OBERHEIM ELECTRONICS, INC.
ENGINEERING CHANGE ORDER

ECO NO.
201

DSX

ECO NO.
202
(2 SHEETS)

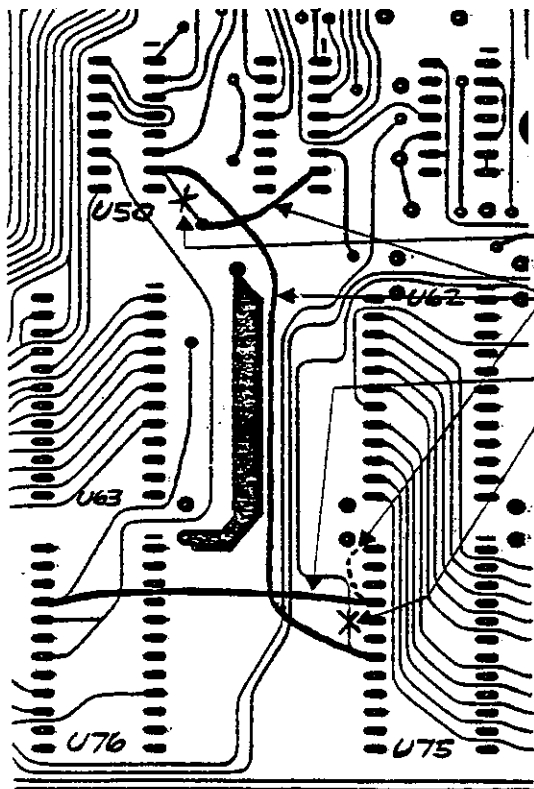
1. REMOVE DSX PROCESSOR BOARD BY DISCONNECTING CONNECTORS A THROUGH E AND UNSCREWING THE TEN SCREWS.
2. REMOVE JUMPER BETWEEN U75 PIN 24 AND U75 PIN 21 ON BACK OF BOARD.
3. CUT TRACE BETWEEN U75 PIN 18 AND U46 PIN 9 ON BACK OF BOARD.
4. CUT TRACE BETWEEN U50 PIN 7 AND FIRST FEED-THROUGH ON BACK OF BOARD.
5. ADD JUMPER BETWEEN U50 PIN 7 AND U75 PIN 18 ON BACK OF BOARD.
6. ADD JUMPER BETWEEN U75 PIN 21 AND U76 PIN 21 ON BACK OF BOARD.
7. ADD JUMPER BETWEEN U49 PIN 7 AND FEED-THROUGH ON BACK OF BOARD.
8. PLACE BOARD BACK IN CHASSIS AND RECONNECT ALL CONNECTORS AND SCREWS.
9. REPLACE E-PROMS:
E-PROM 'C0' GOES INTO U76
E-PROM 'C1' GOES INTO U63
E-PROM 'C2' GOES INTO U75

TO ALLOW FOR EXTRA STORAGE OF NEW SOFTWARE BY CHANGING U75 FROM A 2716 E-PROM TO A 2732 E-PROM.

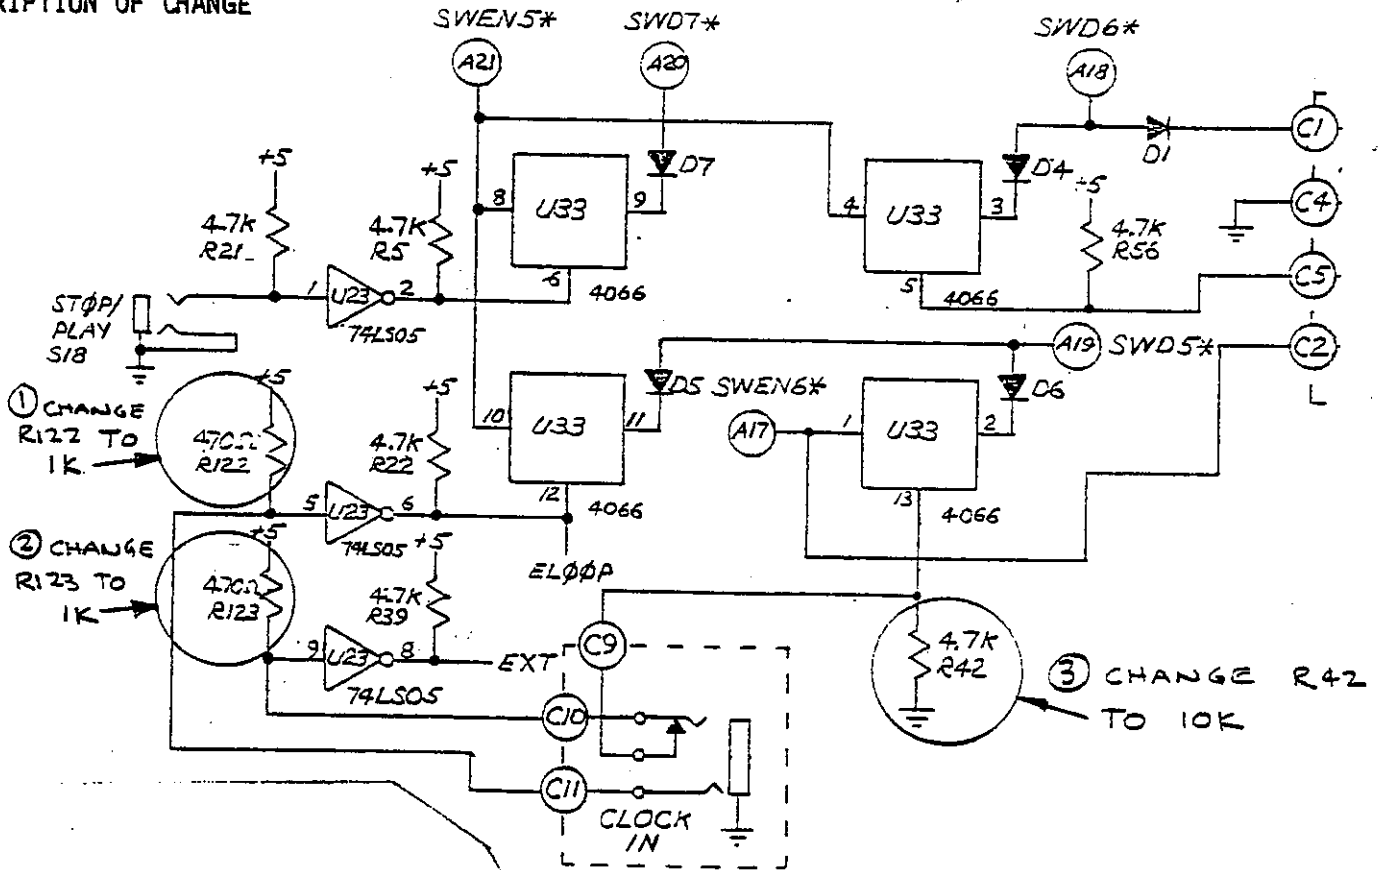
TO REDUCE CLOCK NOISE WHEN DSX IS SLAVED TO DMX

SCHEMATIC 1519 A SHEET 3 OF 3

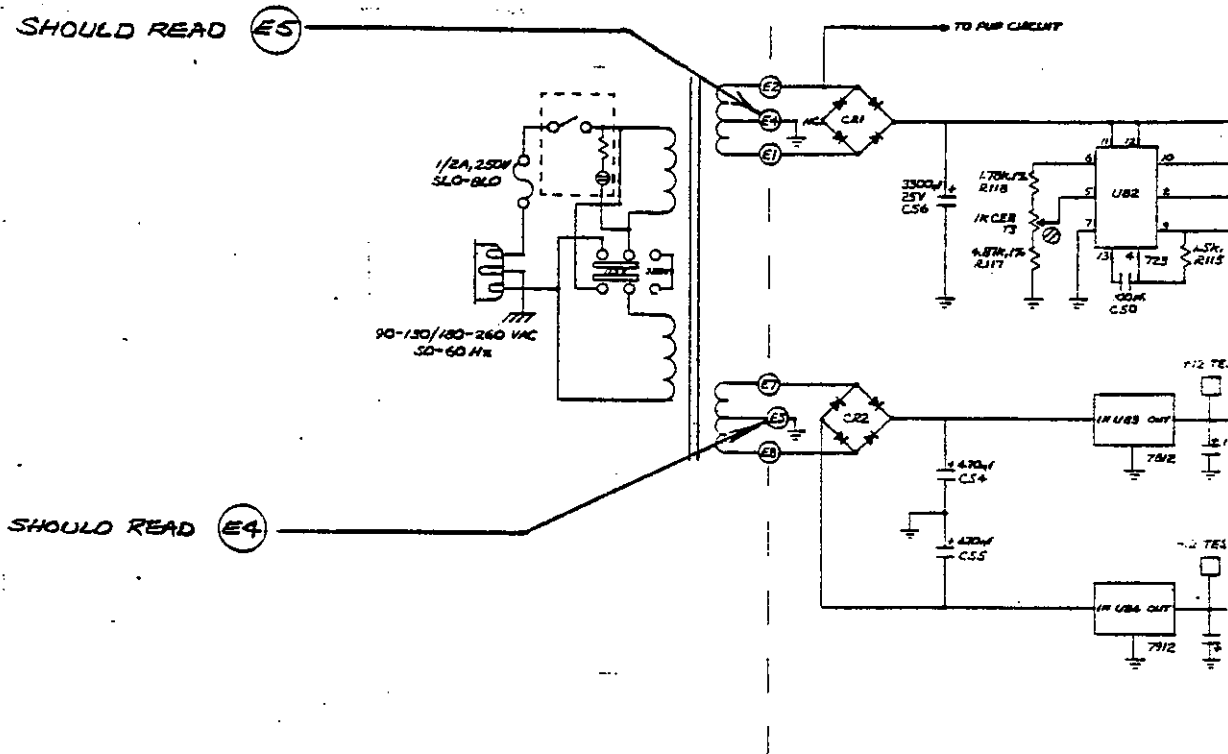
PIN NUMBERS INCORRECT. SCHEMATIC ONLY.

ECO NO.
208

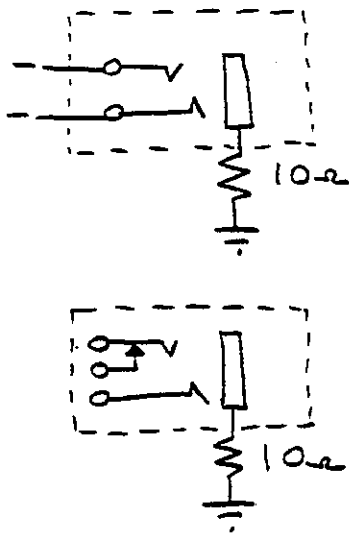
- 1) REPLACE JACKS WITH INSULATED TYPES (SWITCHCRAFT N-114B)
- 2) ADD 10 Ω RESISTORS TO GROUND

ELIMINATE GROUND LOOPS

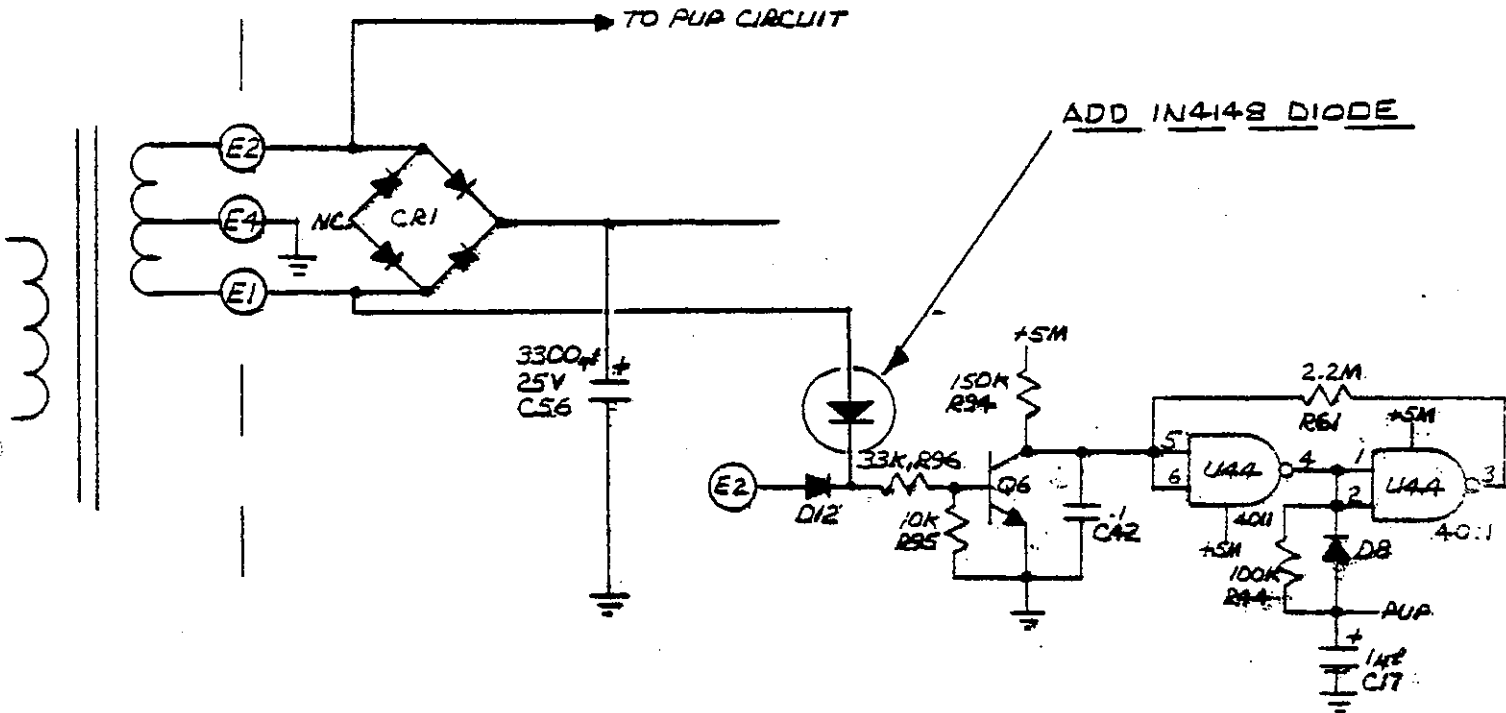
IMPROVE MARGIN OF "PUP" CIRCUIT TO INADVERTENT
TURN-OFF, ESPECIALLY AT 50 HZ

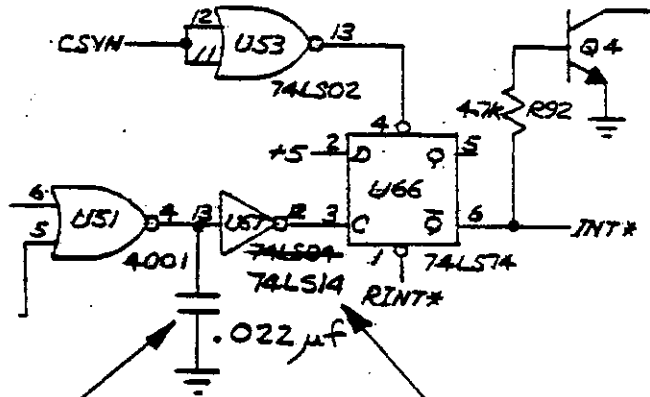
1) ADD .022 CAP.

2) CHANGE U67 TO 74LS14

REDUCE SUSCEPTIBILITY OF "CLOCK-IN"
INPUT TO NOISE

ECO NO. 211
PAGE
1 OF 2

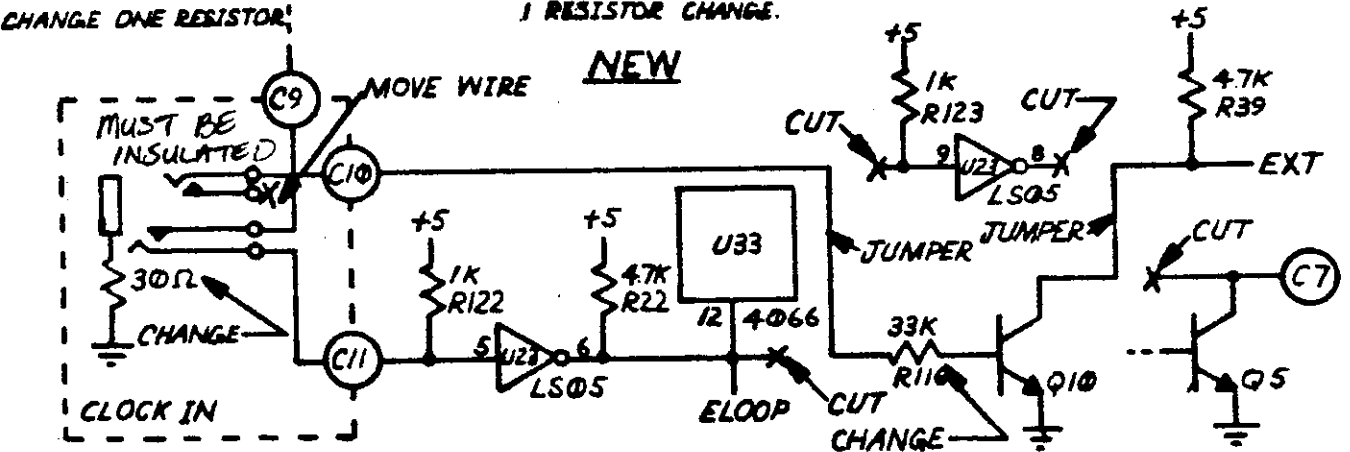
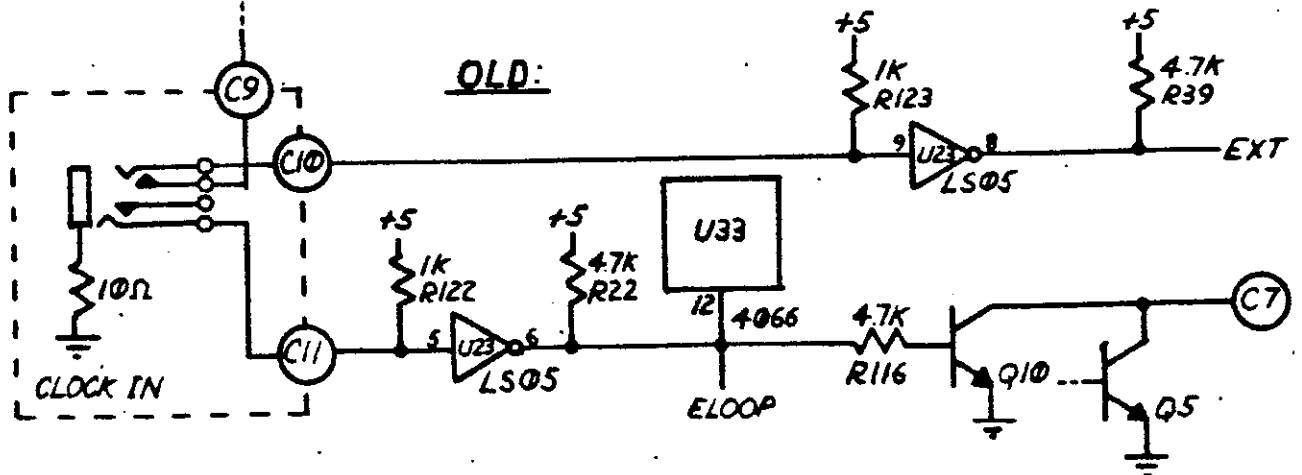
TO ELIMINATE CLOCK NOISE AND GROUND HUM WHEN CONNECTING THE DMX OR DX CLOCK OUT TO THE DSX CLOCK IN.

*NEW: ON BACK PANEL
MOVE ONE WIRE
CHANGE ONE RESISTOR!*

*ON PROCESSOR BOARD:
4 CUTS, 2 JUMPERS,
1 RESISTOR CHANGE.*

NOTE: JACK MUST BE ISOLATED FROM CHAS&TS.

ECO NO. *212*

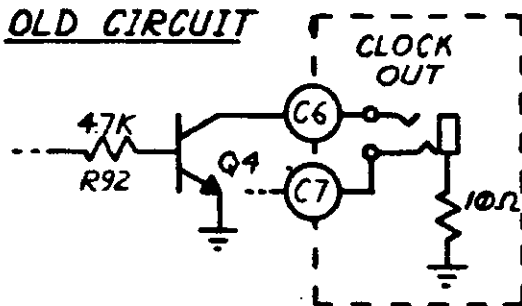
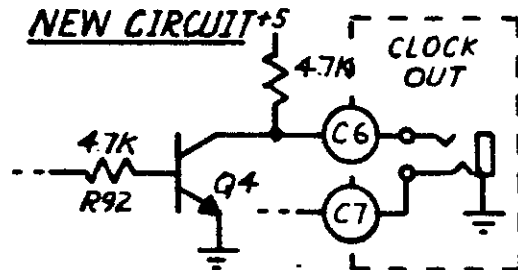
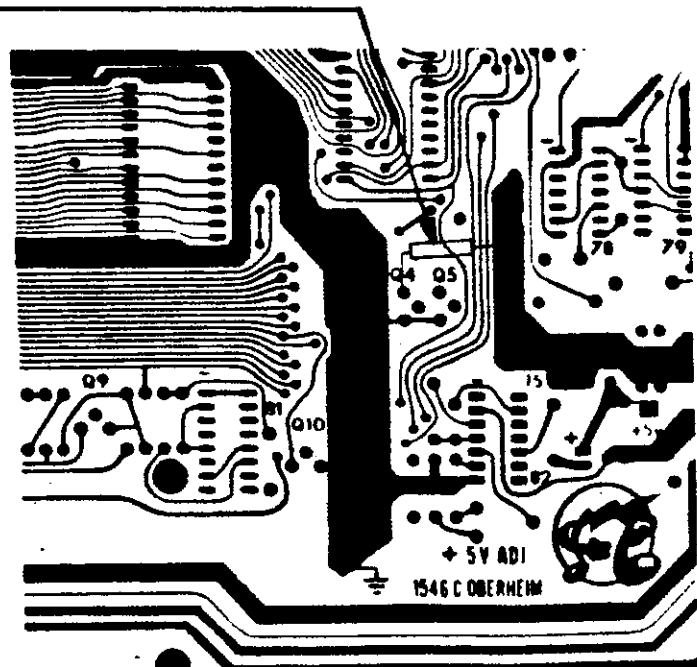
TO ELIMINATE CLOCK NOISE WHEN CONNECTING DSX CLOCK OUT TO DMX CLOCK IN. ALSO ALLOWS TWO DSX'S TO BE CLOCKED TOGETHER WHEN ECO. 211 HAS BEEN IMPLEMENTED.

ADD A 4.7K PULL UP RESISTOR TO THE COLLECTOR OF Q4.

REMOVE 10Ω RESISTOR ON CLOCK OUT JACK AND CONNECT JACK SLEEVE TO GROUND.

215

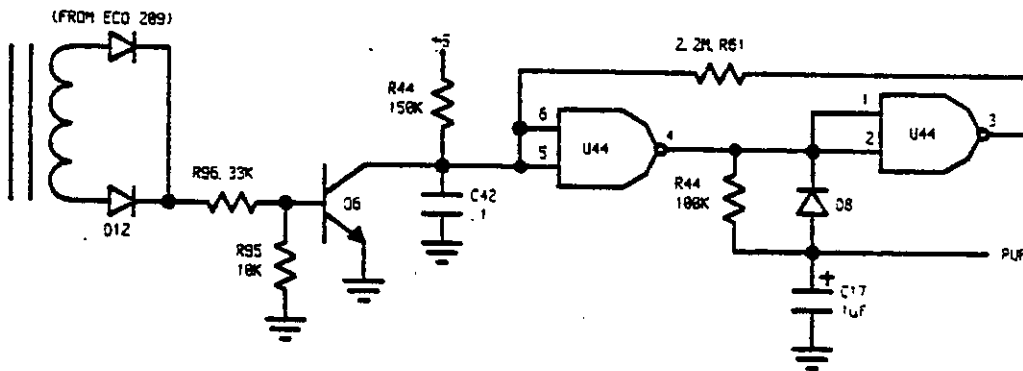
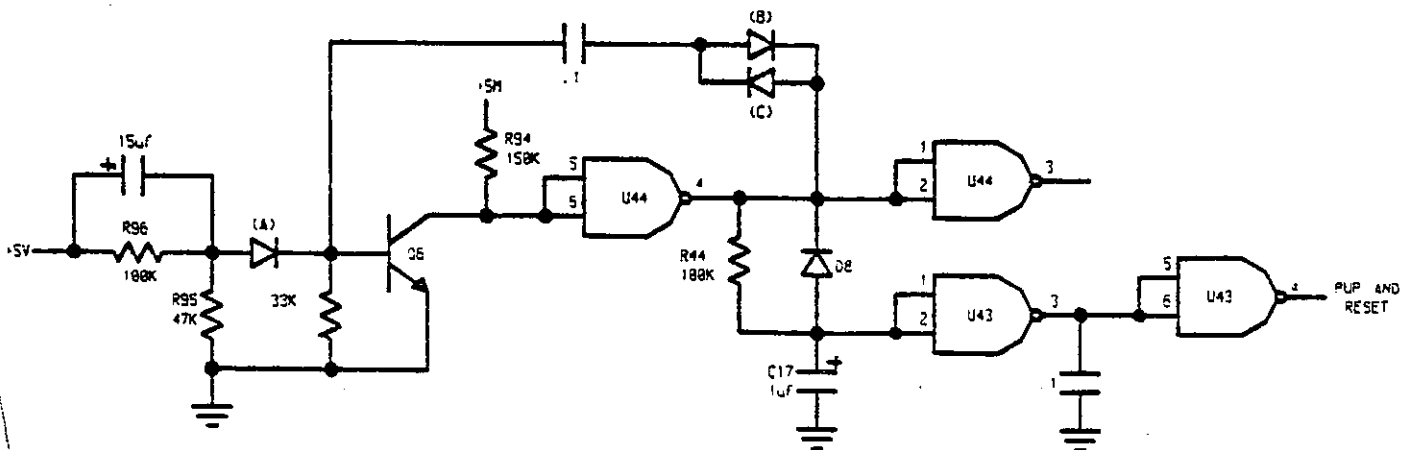
IMPROVE RELIABILITY OF MEMORY RETENTION.

216

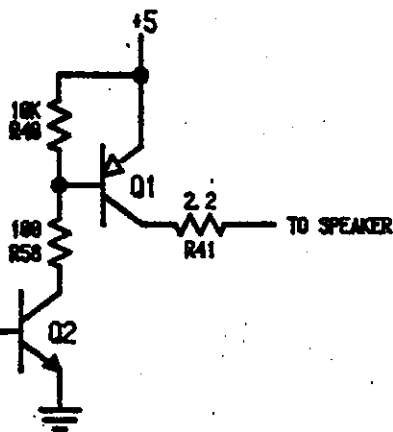
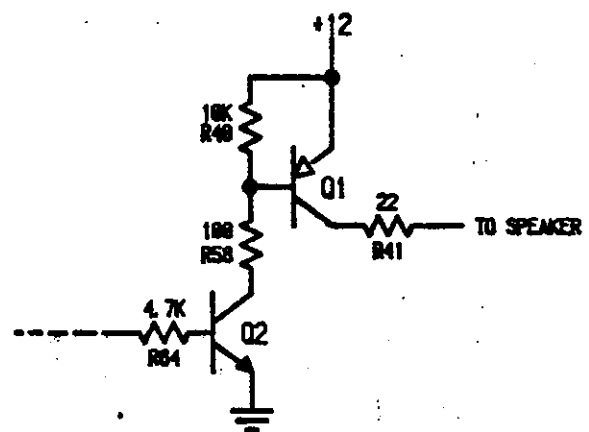
TO REDUCE CURRENT DRAW ON +5 SUPPLY FROM SPEAKER,
WHICH SOMETIMES CAUSES PUP TO FALSE TRIGGER.

1. CUT +5 TRACE GOING TO TOP OF R40 AND EMITTER OF Q1 ON TOP OF BOARD.
2. JUMPER +12 FROM PIN 1 OF r2 RESISTOR SIP TO EMITTER OF Q1.
3. REMOVE RESISTOR R41 (2.2 OHMS) AND REPLACE IT WITH A 22 OHM RESISTOR.
